Amendment Application (ED Act)

Town Planning Assessment

The Amendment Application relates to the existing PDA Development Approval over the site at 11 Macarthur Avenue, Part 23 Macarthur Avenue, Part 1A Macarthur Avenue, Part 7 Wharf Street, and Part 11 Wharf Street, Hamilton for a PDA Development Permit for Material Change of Use for Mixed Use High Density Multiple Dwelling, Office (Co-working space), Shop (Dog grooming station), Food and Drink Outlet (Café), Parking Station (Car share scheme) and Indoor Sport and Recreation (Gym) (DEV Reference Number: **DEV2023/1402**). The development approval includes a 24-storey residential-led, mixed-use development, comprising a consolidated podium and two (2) towers, including 560 residential units and 965m² of retail and commercial space on ground and mezzanine levels. A copy of the current approval is included in **Appendix A**.

Figure 3: Approved Ground Floor Plan (Source: Fender Katsalidis, 2023)

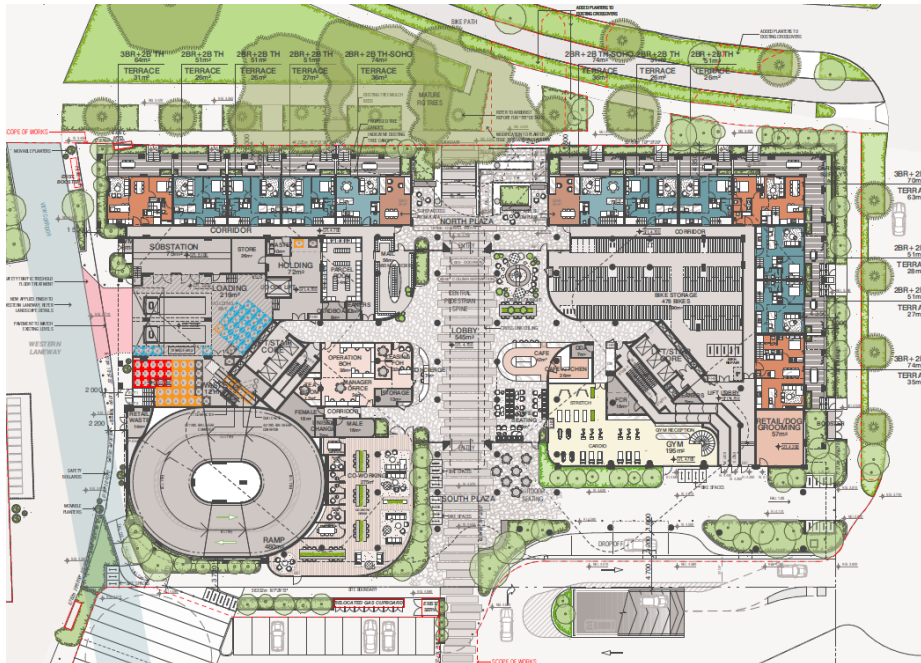
- The proposed change involves removal of the basement and replacement of the approved mezzanine level with a full level of podium parking. The podium continues to have a building height of five (5) storeys, consistent with the development approval, and is suitably sleeved and screened.

- Vehicle access to the development is proposed from the existing southern driveway via an internal driveway. The access has changed as a consequence of removing the basement.

Figure 5: Approved set down area (Source: Fender Katsalidis, 2025)

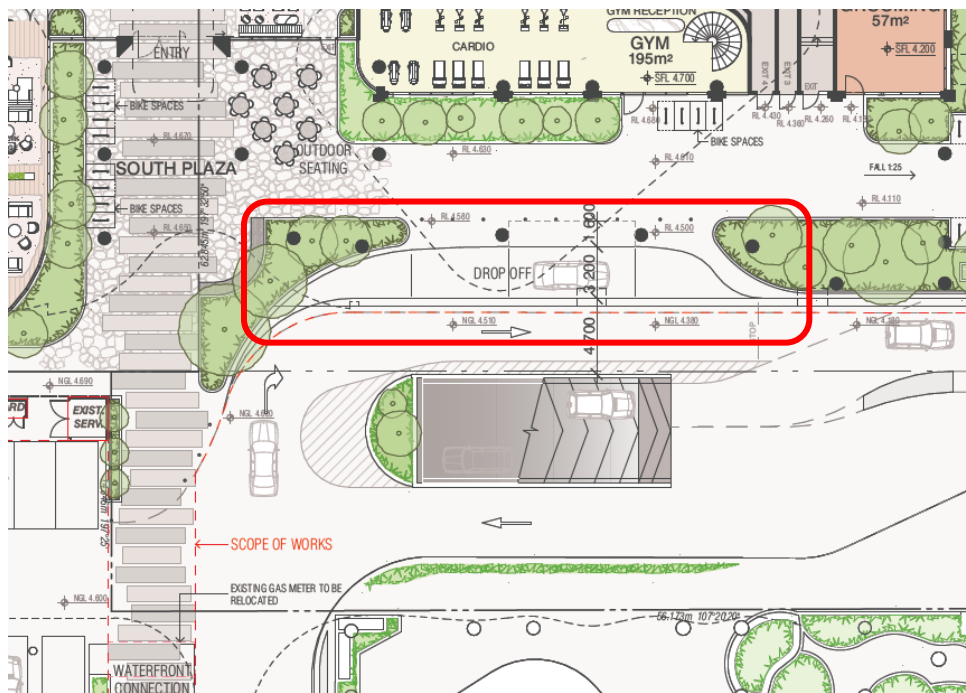
- Removal of the approved set down area for taxi's and rideshare vehicles at ground level. The development provides sufficient resident and visitor car parking spaces and vehicle drop off may occur within the internal driveway. Refer to **Figure 5** below and the Architectural Package (**Appendix C**) for further detail.

Figure 6: Approved service bay location (Source: Fender Katsalidis, 2023)

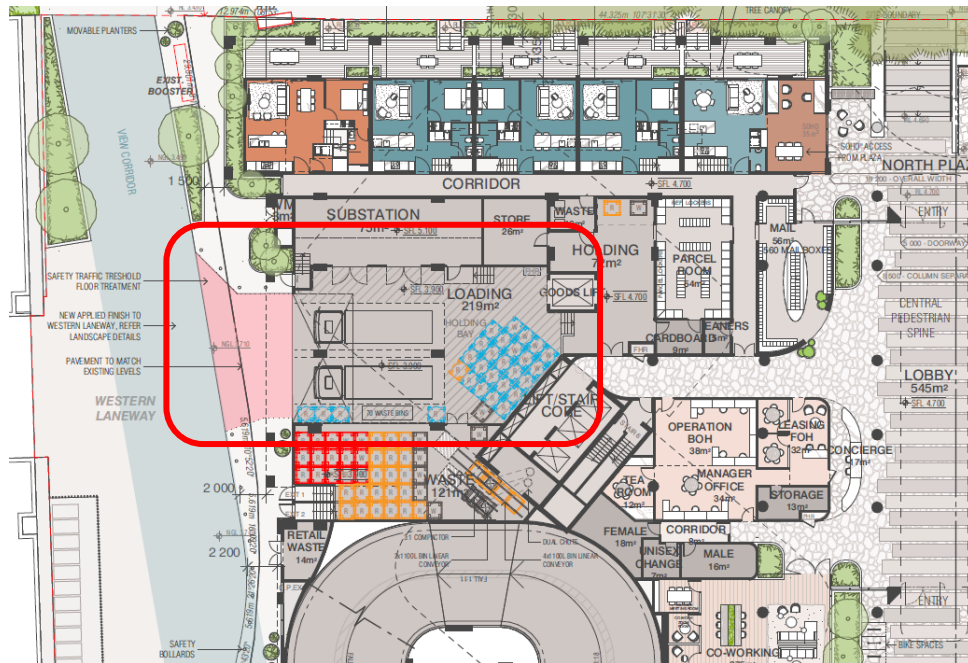
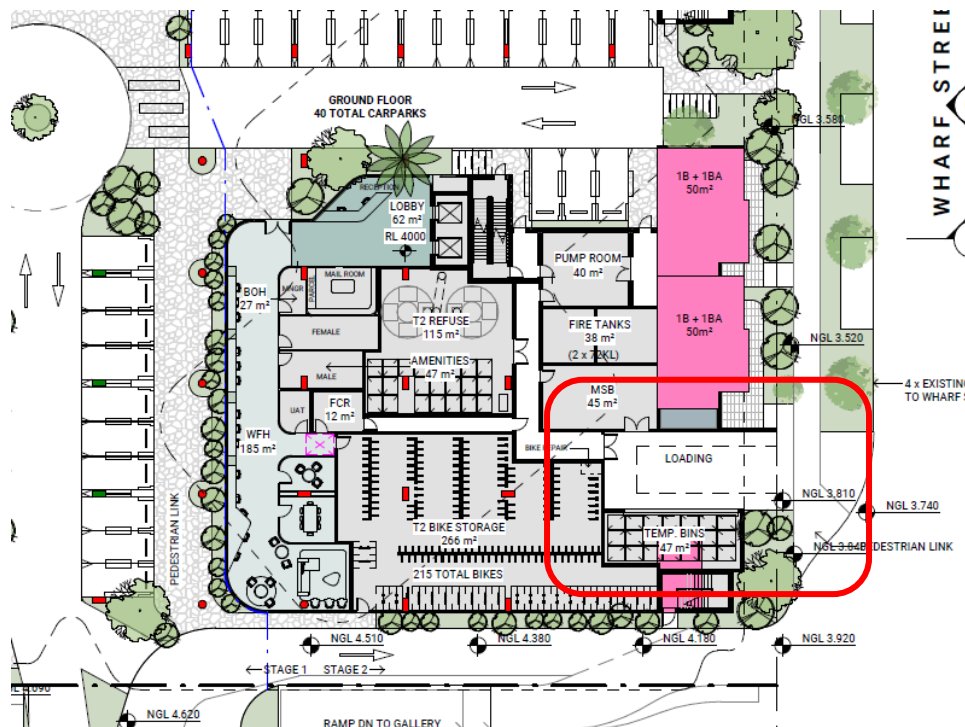
A second servicing bay has been integrated at the ground level below Tower 2 and accessible from Wharf Street. The proposed change provides for a service bay for each respective tower, delivering a more efficient outcome from a delivery, removalist and refuse collection perspective. Refer to **Figures 6 - 8** below.

The development proposes to maintain the loading bay accessible via the western service laneway, albeit with the following changes.

- Reduction in the number of loading bays provided within the western loading bay, from two (2) to one (1) loading bay; and

- Repositioning of the Tower 1 service bay (to the west) further south behind the podium carparking ramp.

Figure 10: Proposed Ground Floor Level and Pedestrian Link (Source: Plus Architecture, 2025)

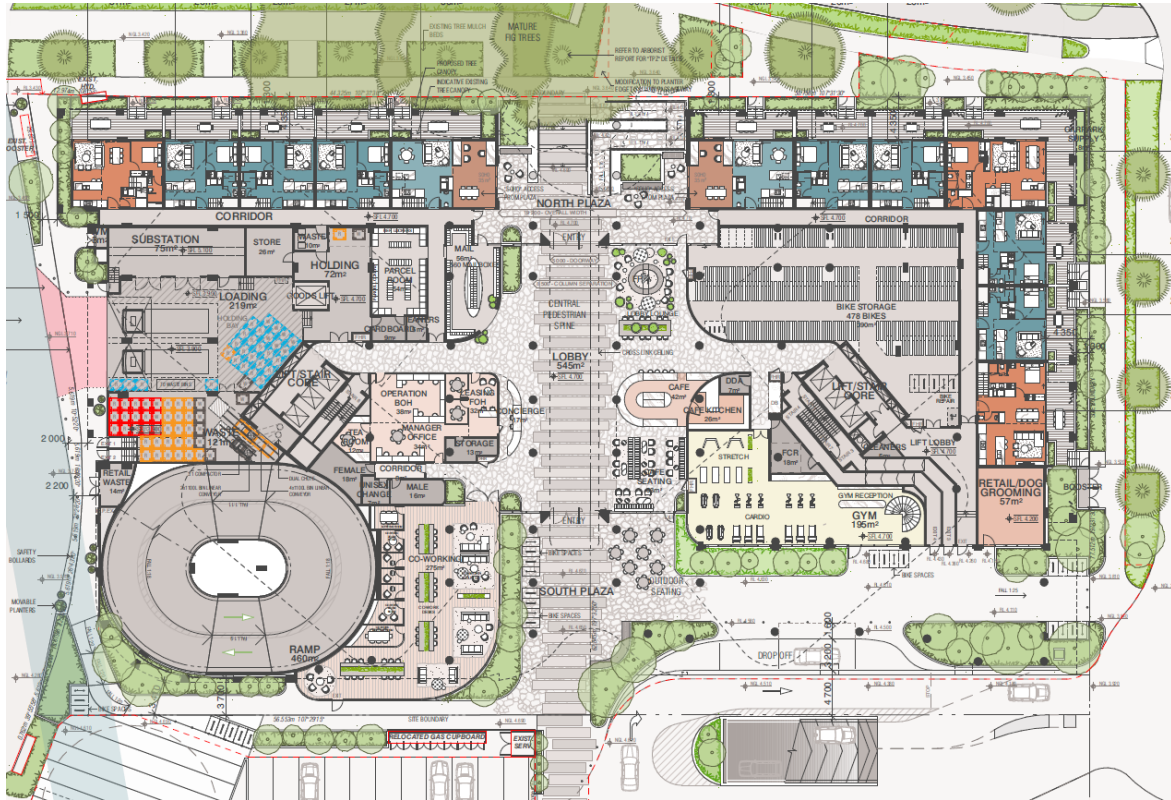
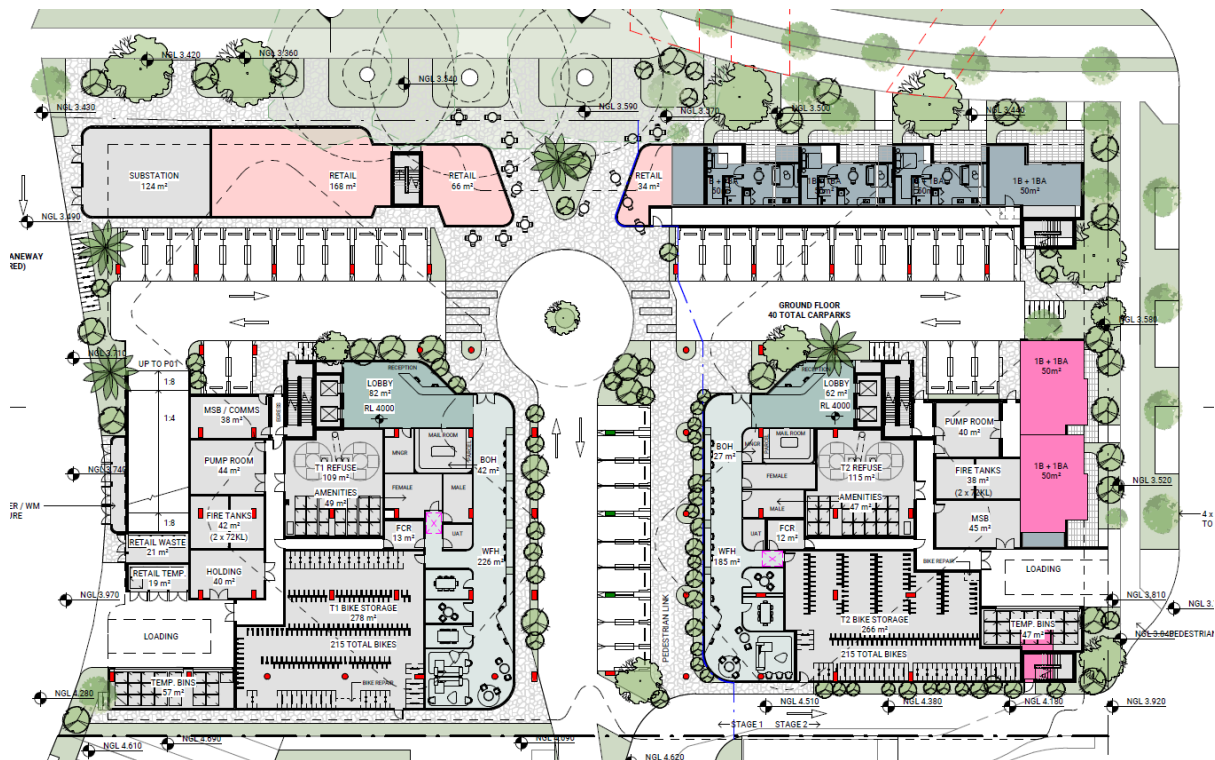
The connectivity, functionality, design, quality and activation of the proposed ground floor level remains coherent with (and in some circumstances improves) the development approval. The approved ground level outcome is illustrated in **Figure 9**.

The proposed change achieves a highly activated ground level plane and well-defined north-south cross block link that runs centrally throughout the site, in accordance with the approved development. Fundamental elements of the approved ground level have been integrated as part of the proposed change (as described below), in addition to other integrated features to facilitate increased activation and amenity, for the site and adjoining public and pedestrian environments.

- Provision of a centralised cross block link that runs in a north-south direction through the site. As illustrated in **Figure 10** below, the north-south link will connect the greenspace within the Macarthur Avenue Road reserve and provide the opportunity to continue the link through the land to the south

- The development approval included a central pedestrian connection, however it included doors at either end, enclosing the connection and reducing its functionality as a publicly accessible connection, and was only partially anchored by active uses. The development proposes to remove the doors and encourage a publicly accessible space that is integrated with its broader locality.

Figure 15: Proposed Rooftop Communal Space Outcomes (Source: Verde Design, 2025)

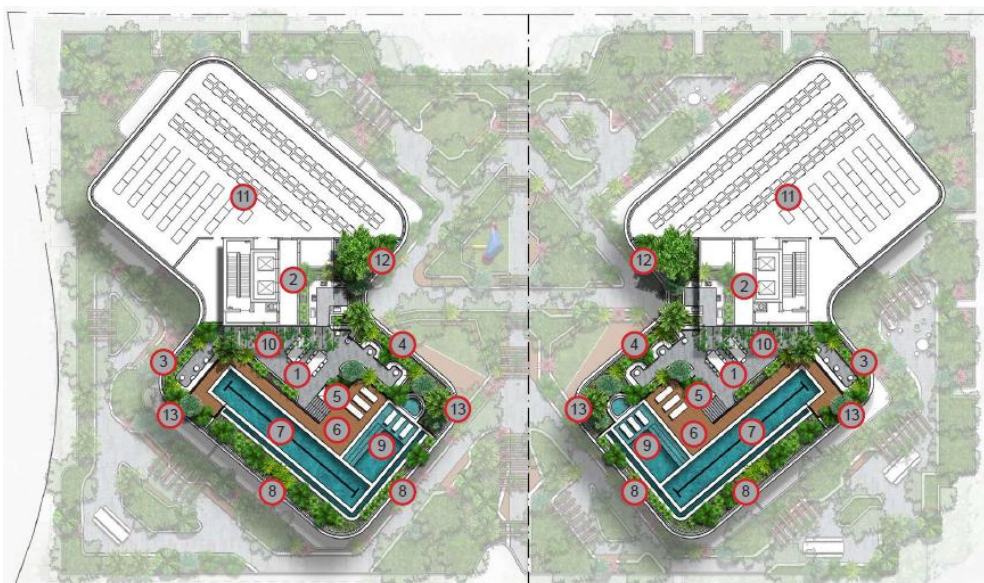
- The rooftop of each tower includes communal open space, totalling 1,098m²
- Each rooftop includes a pool, deck / lounge area, dining and seating spaces and landscaping.

Figure 16: Staging (Source: Plus Architecture, 2025)

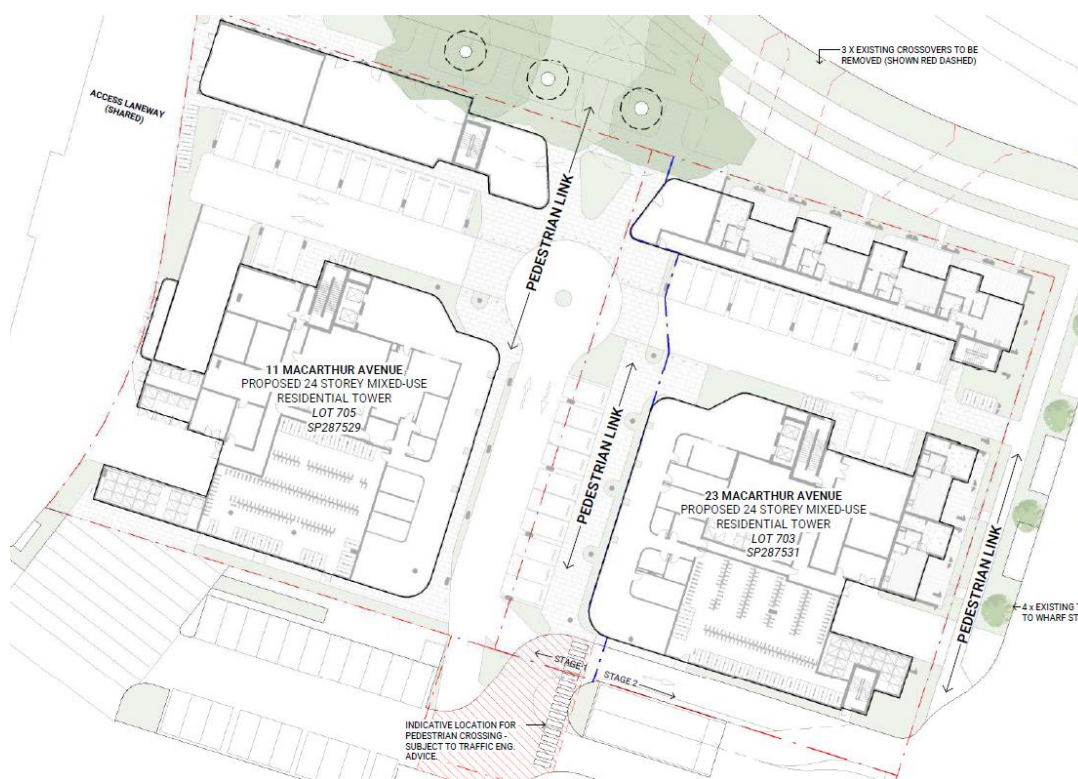
- Stage 1: Tower 1, including half of the podium and the portion of the ground level below tower 1, including the cross block link and vehicle driveway.
- Stage 2: Tower 2, including the balance of the podium and ground level.

Figure 16 illustrates the proposed staging outcome.
